## ADDENDUM NO. 2

### Rowland Unified School District

### Alvarado Intermediate School Partial Modernization

DSA No. 03-112358

<b>DRINKING FOUNTAIN</b>		(REF. 16/A-9.2)	SCALE: N.T.S.
PROJECT TITLE: ALVARADO I.S. PARTIAL MODERNIZATION	DSA NO.: 03-112358 PROJECT NO.: 108RSD13 HENRY WOO ARCHITECTS, INC.	FILE NO.: 19-92	<b>AD2-A9</b> DATE: 3/7/2011

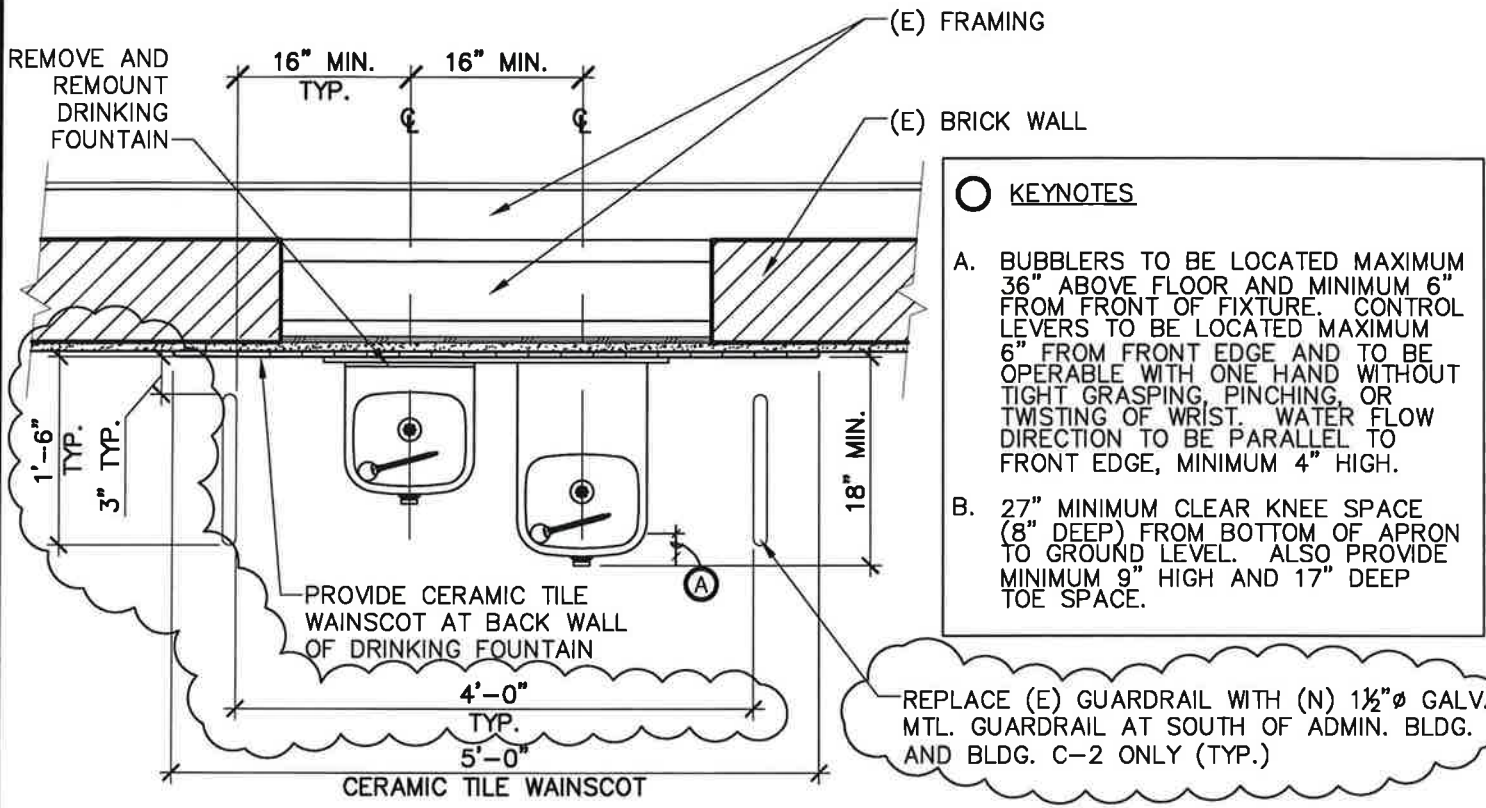
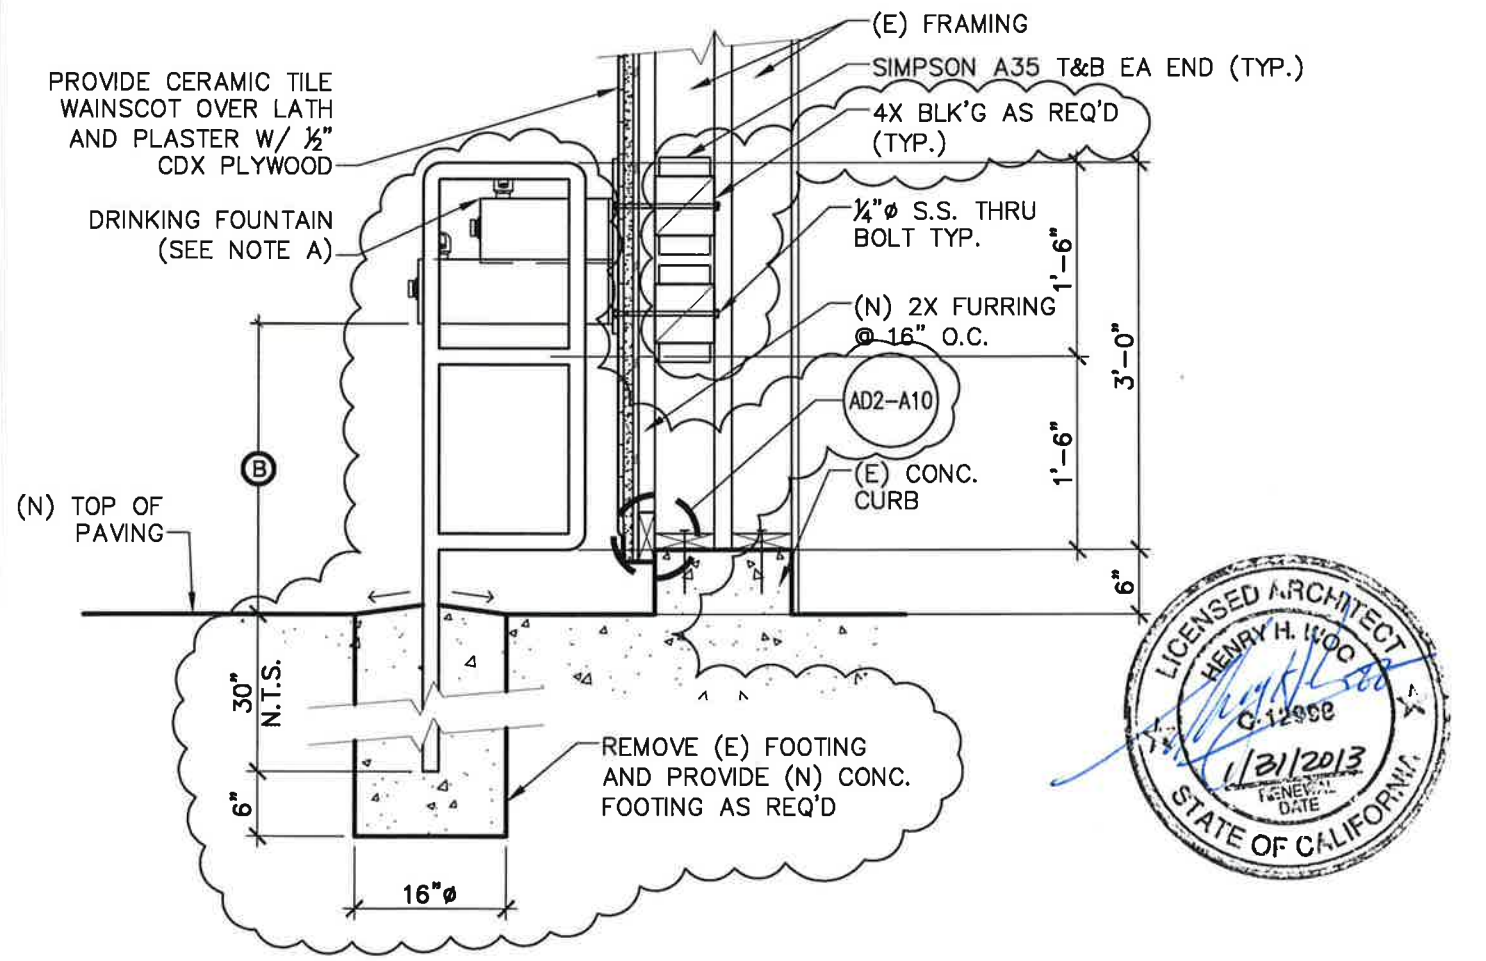
3. Remove all existing guardrails at existing drinking fountains at east wall of Bldg. C-1 and Bldg. C-3.
4. Remove and reinstall existing drinking fountains for new work at South wall of Bldg. C-2 and C-5. (See attached drawing AD2-A9, dated March 7, 2011)

5. Replace all existing guardrails with new at existing drinking fountain at south wall of Admin. Bldg. AL and Bldg. C-2 for new paving work. (See attached drawing AD2-A9, dated March 7, 2011)

REPLACE (E) GUARDRAIL WITH (N) 1 1/2" Ø GALV. MTL. GUARDRAIL AT SOUTH OF ADMIN. BLDG. AND BLDG. C-2 ONLY (TYP.)

**AD2-A11**

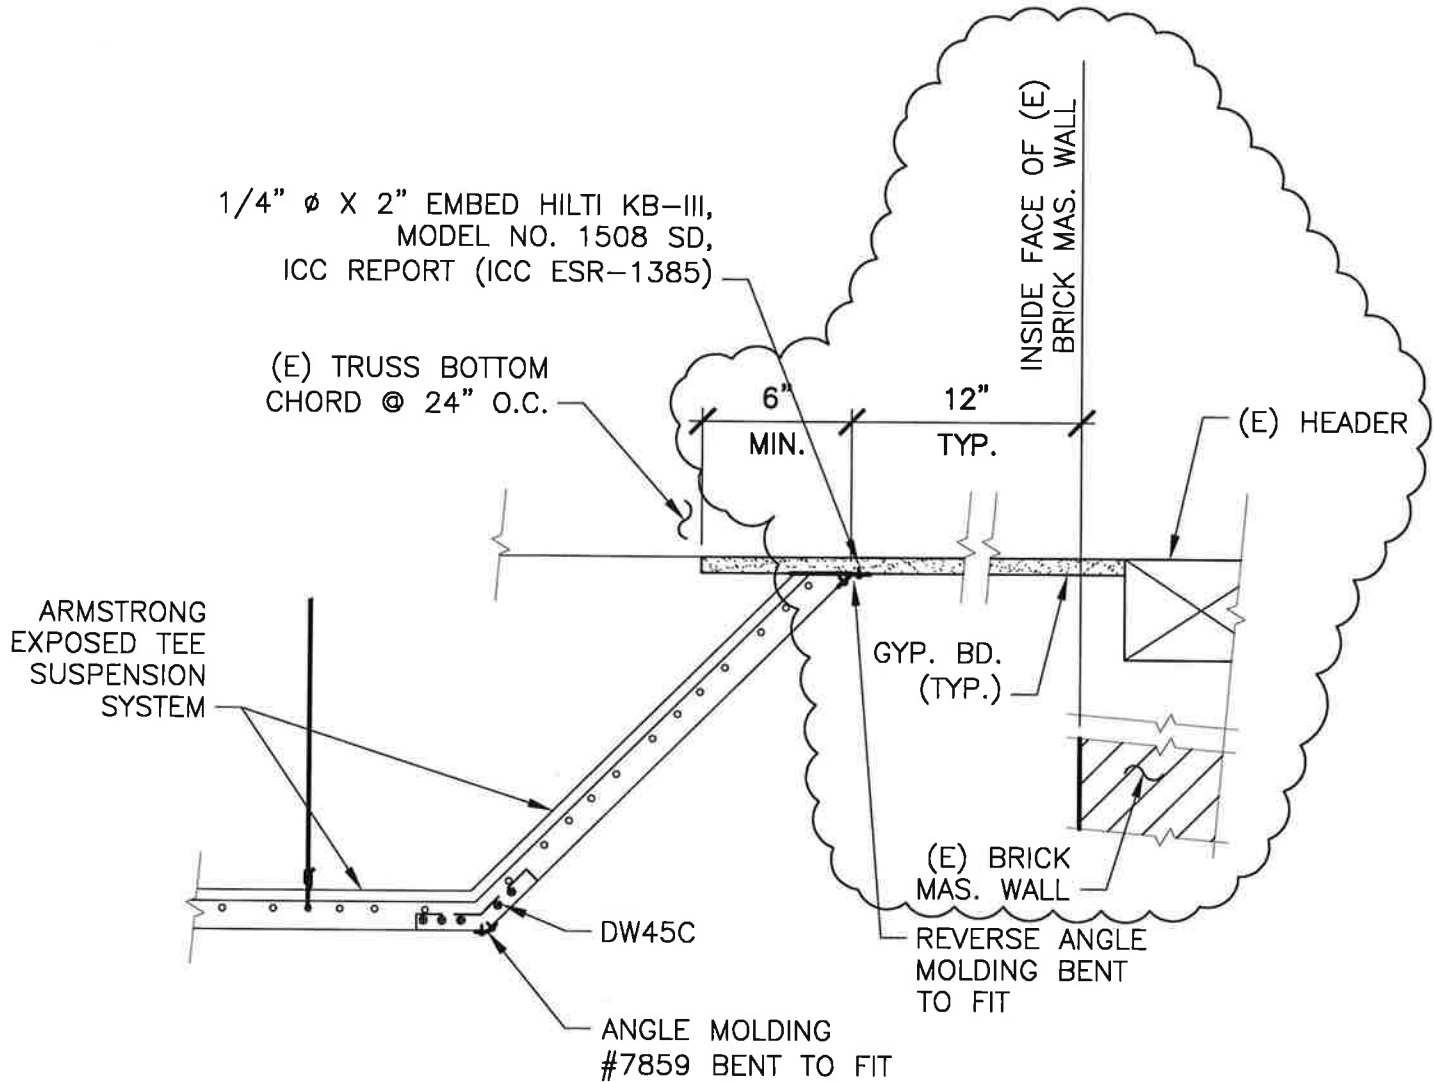
44. REVISE: At Detail 17 - Typical Suspended Ceiling  
Detail per attached drawing AD2-A11, dated March 7, 2011.

**AD2-M1** DATE: 3/7/2011

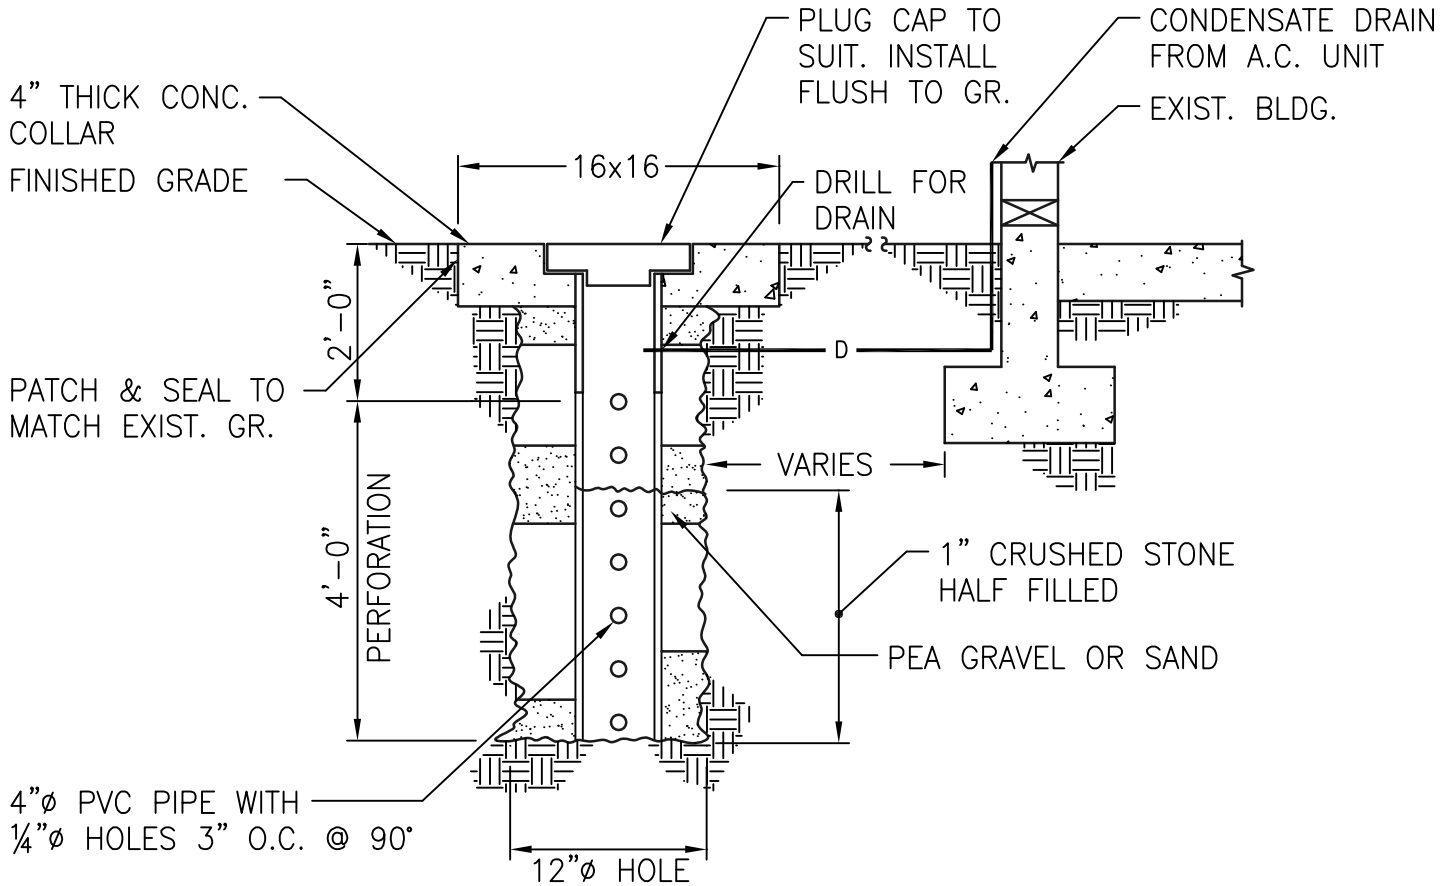
45. At Construction Floor Plans  
For buildings C-1, C-3, C-4, C-5 and C-6: Provide drywell for each Bard wall mounted units for condensate drain. Drywell shall be located in the grass area south of the concrete walkway. Connect new condensate drain to drywell. See attached drawing AD2-M1, dated March 7, 2011. If existing drywell is already in place, contractor shall clean drywell of debris and mud and flush with water.
